FELDMAN KIA PRO JZ24-32

JZ24-32 FELDMAN KIA PRO PLAN WITH REZONING 18.746

Public hearing at the request of Feldman Automotive for initial submittal and eligibility discussion for a Zoning Map Amendment from Non-Center Commercial (NCC) to General Business (B-3) with a Planned Rezoning Overlay. The subject site is approximately 4.88-acres and is located west of Joseph Drive, south of Grand River Avenue (Section 24). The applicant is proposing to develop an automotive dealership with outdoor vehicle inventory, which is not a permitted use in the NCC District.

PLAN REVIEW CENTER REPORT
Planning Review
 September 12, 2024
JZ 24-32 Feldman Kia PRO
 Zoning Map Amendment No. 18.745

SP1.1

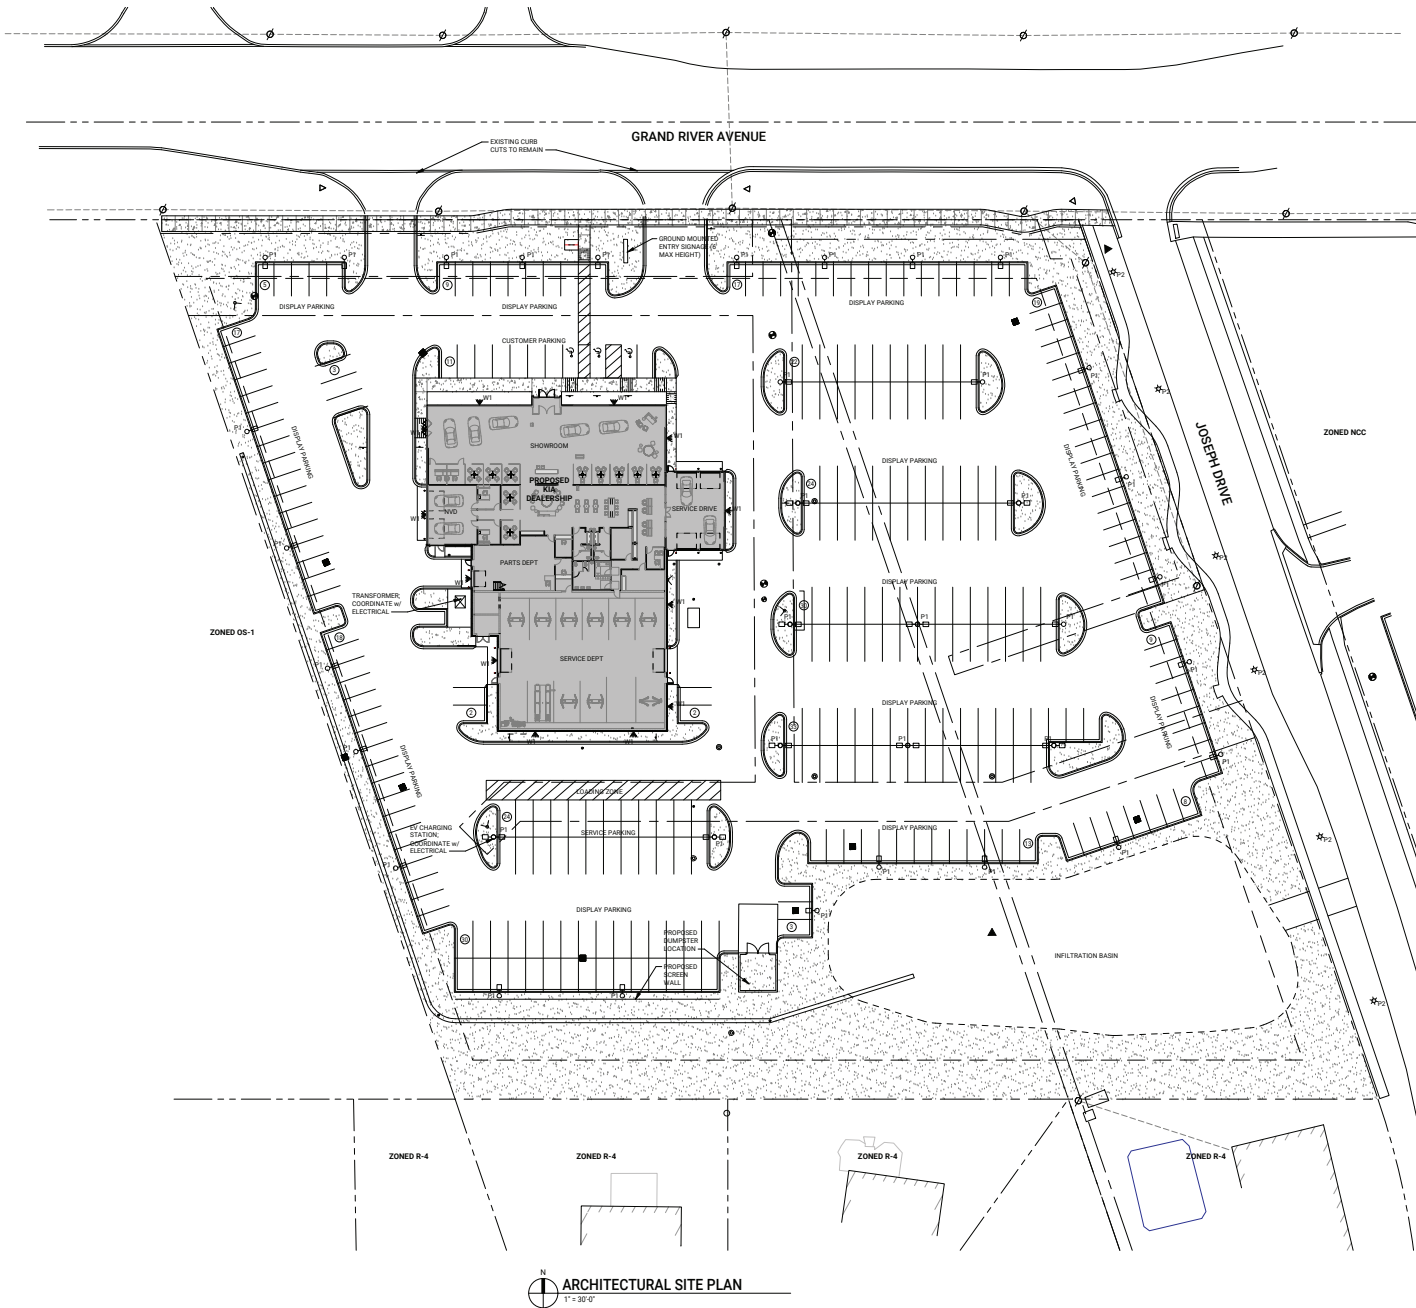
Staff Comment: As noted previously, there is conflicting information regarding the trees on the berm – Sheet 2 indicates they will "remain for screening" and sheets L-1 and L-2 state "Remove all trees as shown and leave all understory and shrubs." Staff is concerned that the proposed removal of existing trees (which are mostly in poor condition and covered in vines) without replanting on the berm does not offer a sufficient buffer to the adjacent residents to the south. If the trees are to be removed the height of the berm should be raised and new trees and/or fencing added on top of it to provide an adequate visual and aesthetic buffer to meet the ordinance requirements for 80% opacity in winter and 90% opacity in summer. This is particularly

SP1.3

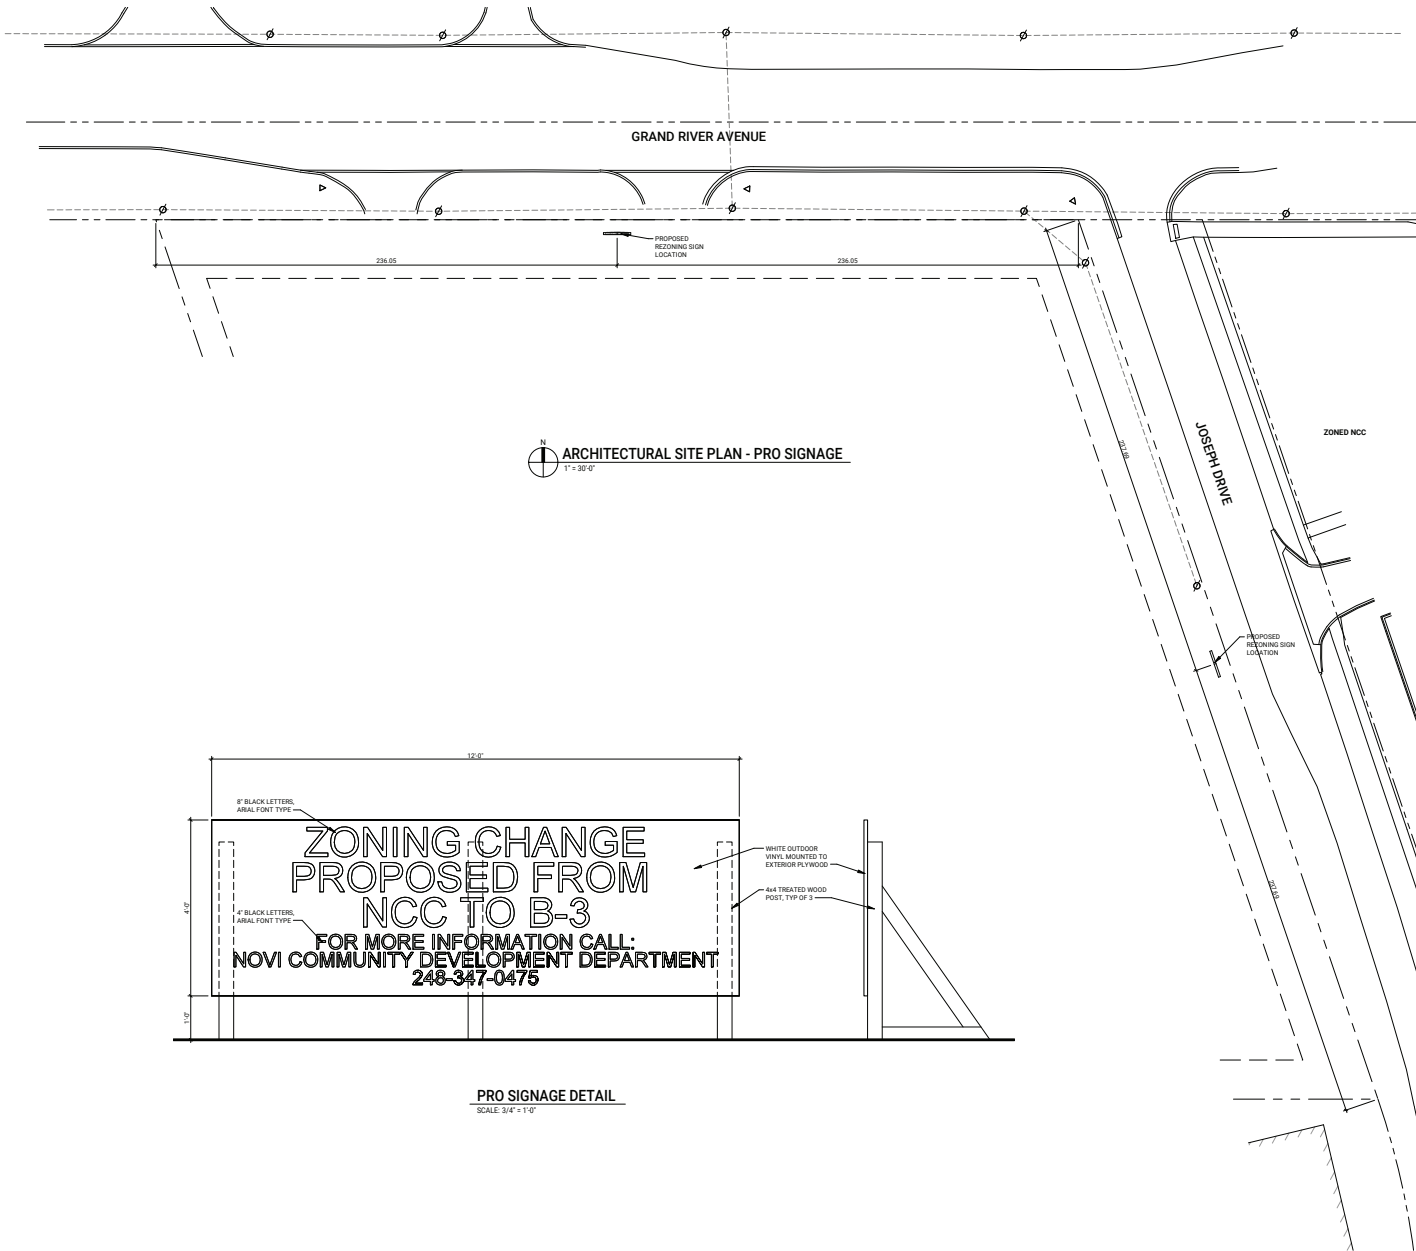
- d. Sign Location Plan: **A rezoning sign location plan and sign detail has been provided on Sheet SP1.3. The sign locations and wording are acceptable.**

3 DUMPSTER ENCLOSURE DETAIL
 SPI.4 1/2" x 1'-0"

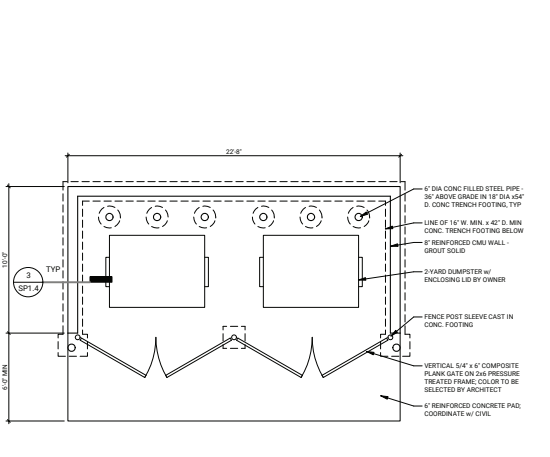
Response: Refer to the updated PRO narrative prepared by Landry, Mazzeo, Dembinski & Stevens PC.
- ***Comment: Dumpster Enclosure – Enclosure detail shown on sheet SP1.4 – enclosure should be brick to match the building. See Façade review.***

A2.1

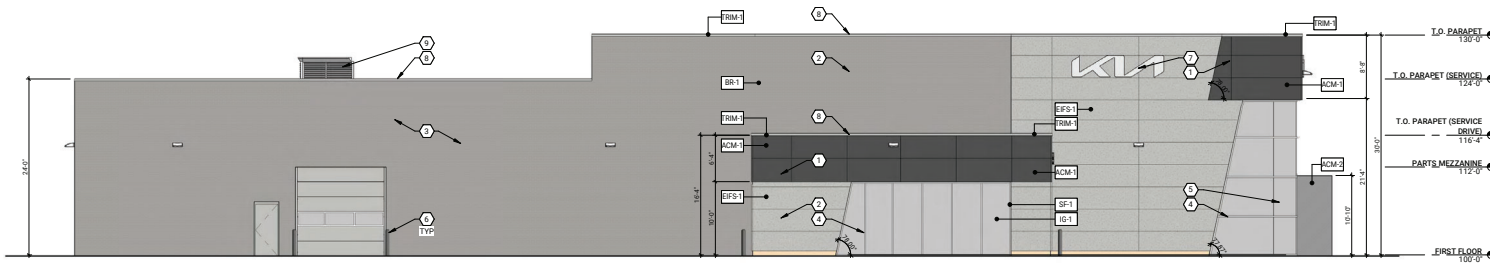
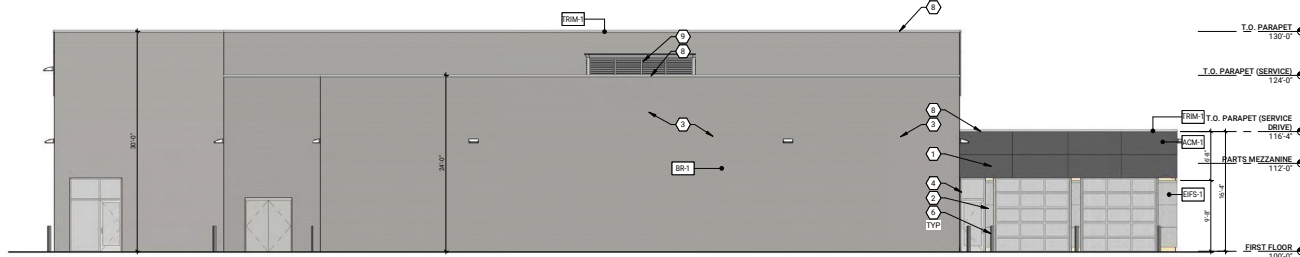
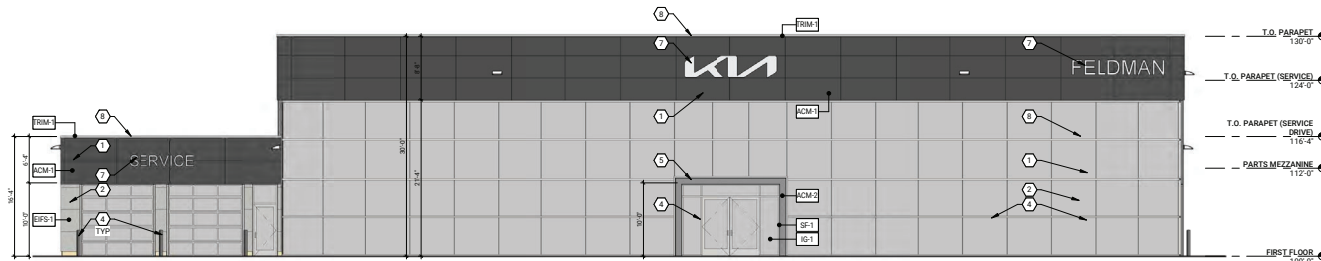
The applicant is proposing 3 wall signs on the north elevation, which is 144 feet from the Grand River centerline ("KIA" 13'x3' = 39 sf, "Feldman" 13'x2' = 26 sf, "Service" = 9'x1.5' = 13.5 sf) with a total area of 78.5 square feet. One sign is proposed on the east elevation ("KIA" 13'x3' = 39 sf). One ground mounted sign, located 60 feet from the street centerline, is shown as 5 feet tall with a total area of about 40 square feet. **The applicant should clarify if these estimated dimensions are correct and provide additional information to be able to evaluate the deviations from the requirements of the sign code: ground sign distance from the centerline of Grand River, and the total area of each sign proposed (box placed around the entire sign area as shown to the right). A Sign Permit Application will be required for each sign proposed.**
